# EcolSciences, Inc.

November 9, 2016

Re: USEPA Comment Letter Response For:  
December 1, 2015 Application for Risk Based PCB Disposal Approval  
450-490 South Avenue and 50 Center Street  
Borough of Garwood  
Block 401, Lots 1 and 2  
Union County, New Jersey  
NJDEP PI# 032470 and 631620

**LOT 1 PCB SOIL SAMPLE RESULTS MAP**

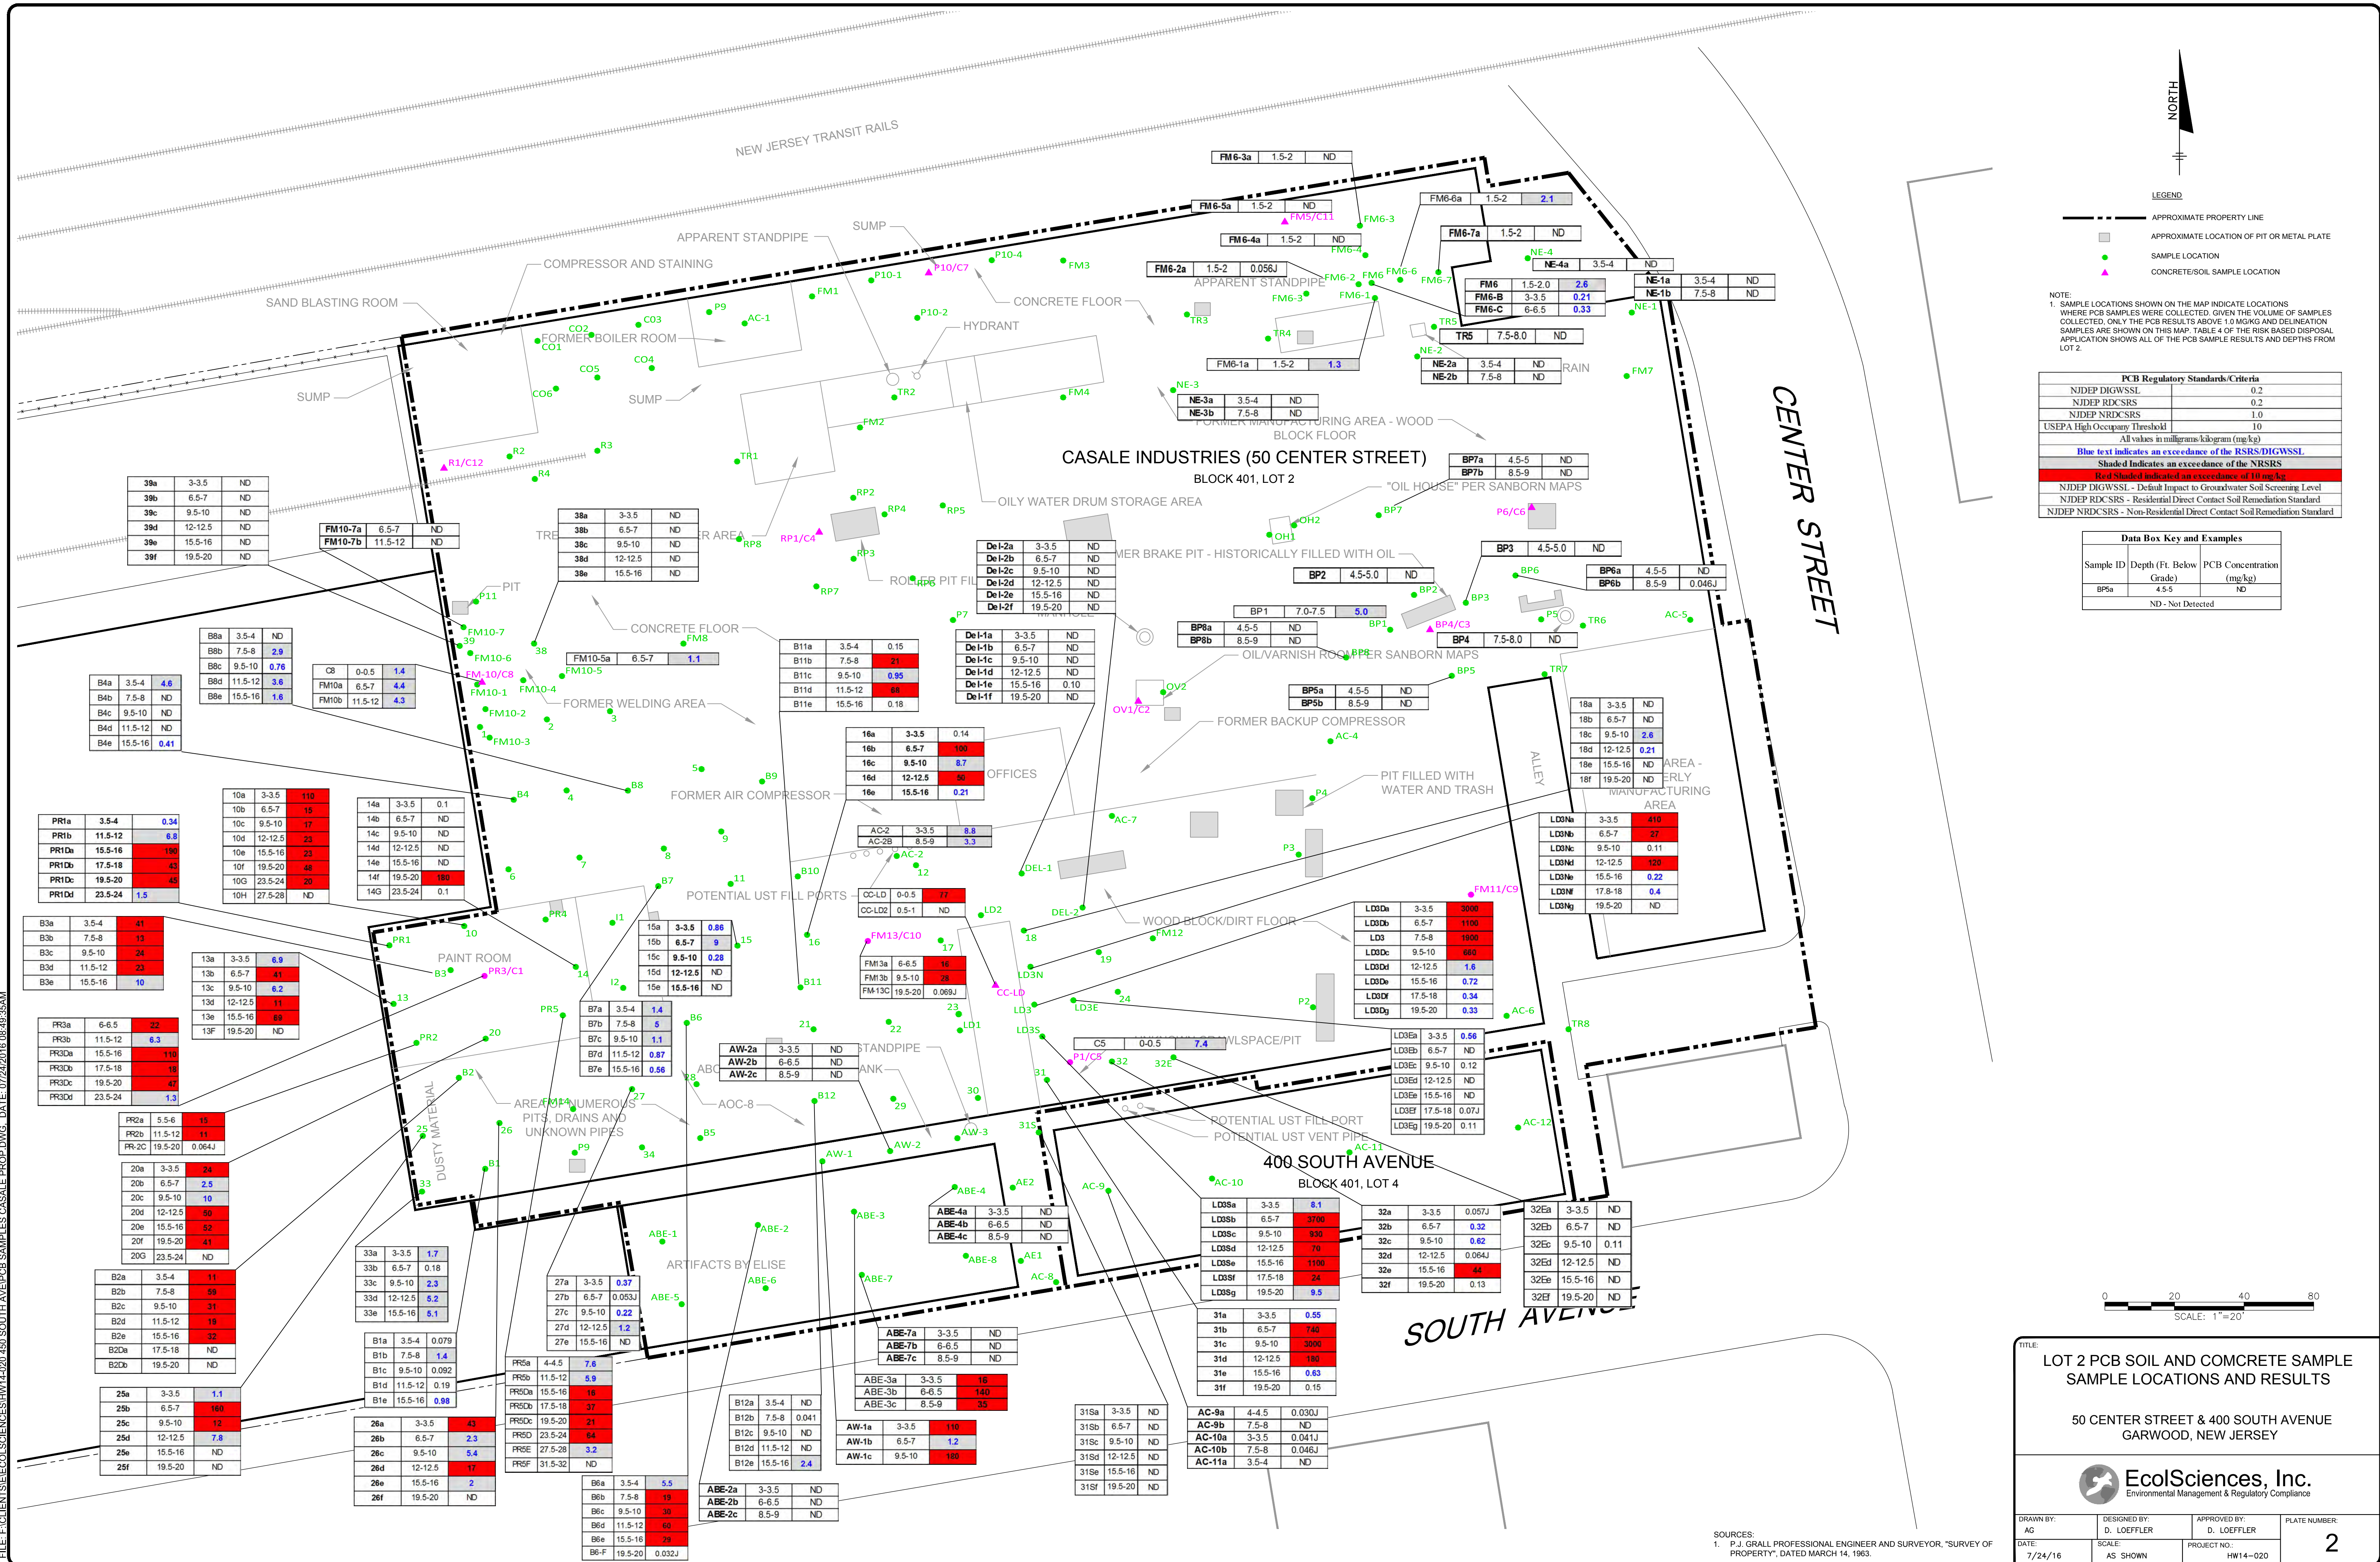
We are also concerned that vertical delineation of PCBs down to at least 10 ppm has not been completed at a number of sample locations as shown on Figures 4 and 5. Please be advised that EPA cannot concur with a cleanup that is not based upon a complete delineation of PCBs.”

PCB sample results were compared to the current NJDEP RDCSRS of 0.2 mg/kg, the NJDEP NRDCSRS and TSCA self-implementing cleanup criteria of 1.0 mg/kg, and the TSCA self-implementing cleanup criteria in (future) Defined High Occupancy Areas of 10 mg/kg. See USEPA Comment Response 5 for a discussion on the PCB sample dates of collection and dates of analysis. All of the PCB samples were analyzed within two weeks of collection in order to comply with NJDEP holding times. Copies of the NJDEP-compliant reduced format laboratory data packages are not included in this Application, but are available upon request. The results of the PCB sampling are included in the tables below and the complete results are included on Table 2 of Attachment A. Figures 1 and 2 in Attachment B present the revised sample location and PCB concentration maps (these are revised Figures 4 and 5 from the December 1, 2015 Application).

Figure Number  
**3**

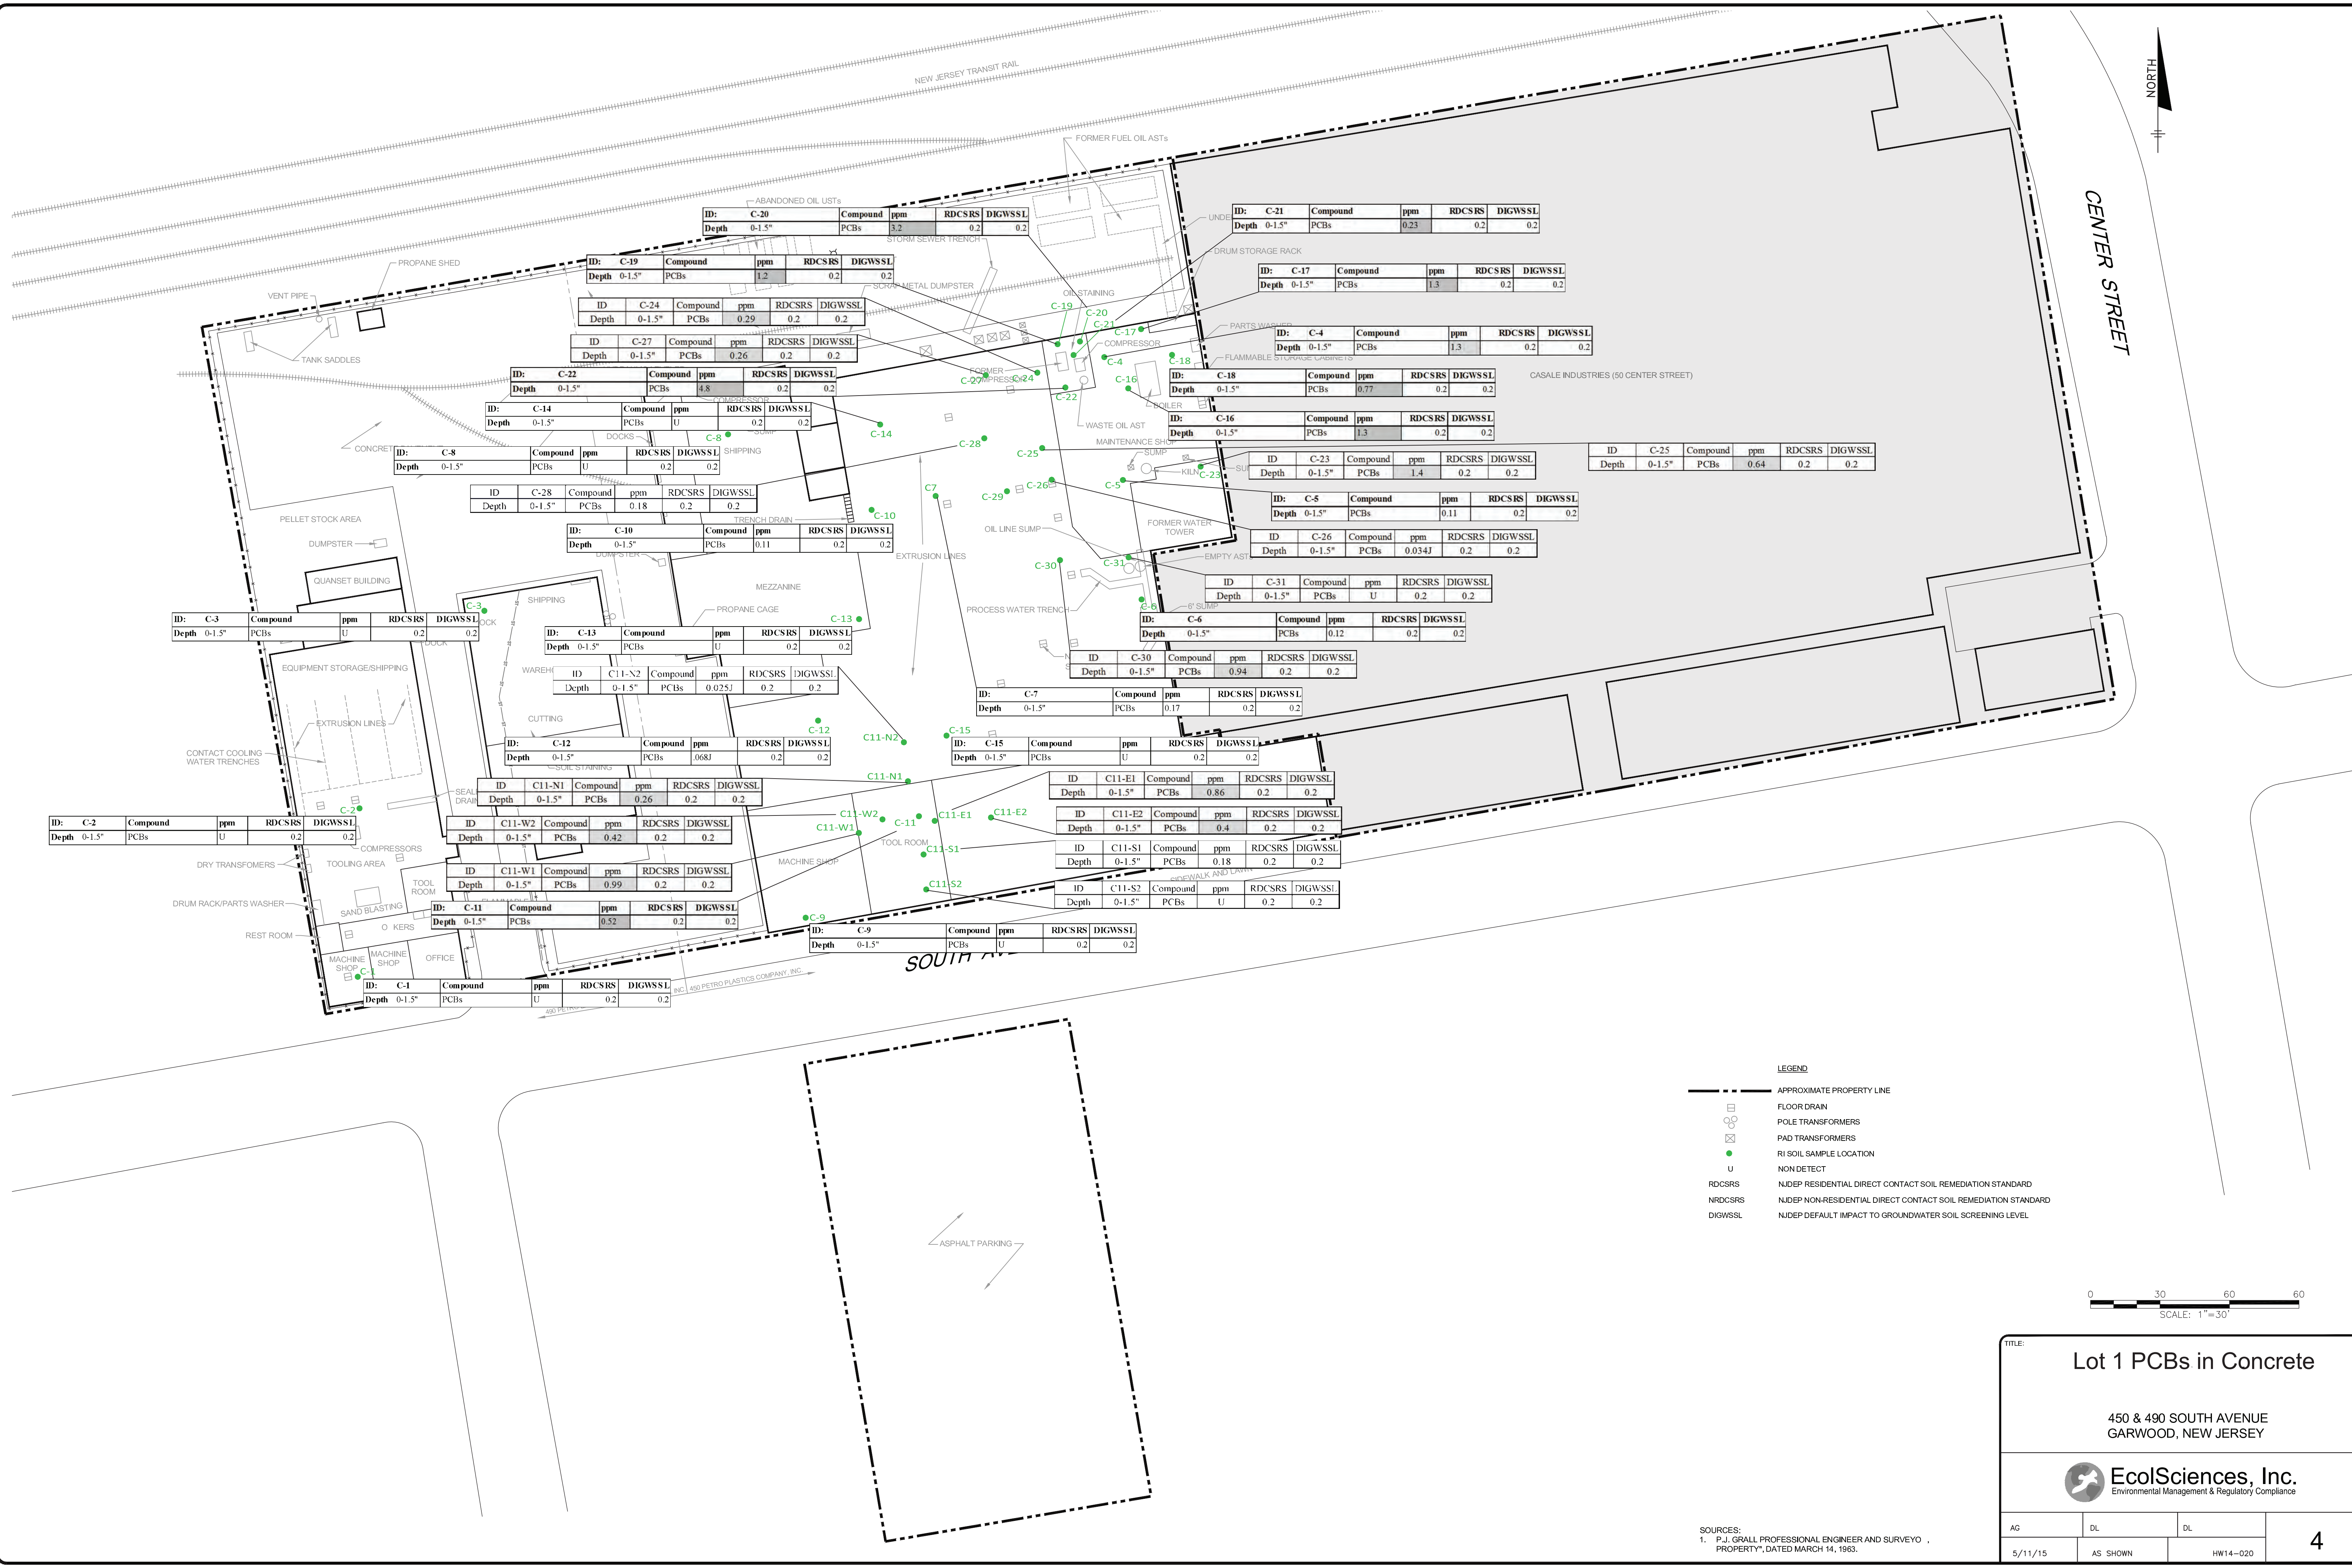
Please provide the PCB sampling results for all of the Site-related wells (not just the wells located within areas impacted by PCBs) as well as a map showing the data that supports the conclusion (as shown on Figure 8) that groundwater flow is generally to the southeast.

The groundwater PCB results and groundwater flow direction, developed using contour mapping programs based on the groundwater levels identified during the June 2016 sampling event, are included on Figure 3. The June 2016 well gauging activities confirmed again that groundwater flow is generally to the southeast, although, as indicated on Figure 3, there is a minor flow component to the south in the northern portion of the Site. This is due to the non-native elevated topography along the rail line to the north of the Site and a limited area of perched water in this portion of the Site. The easterly flow is consistent with regional conditions also well documented on the former Hess gas station property located to the north of the Site, beyond the rail line, based on EcolSciences’ review of NJDEP files.
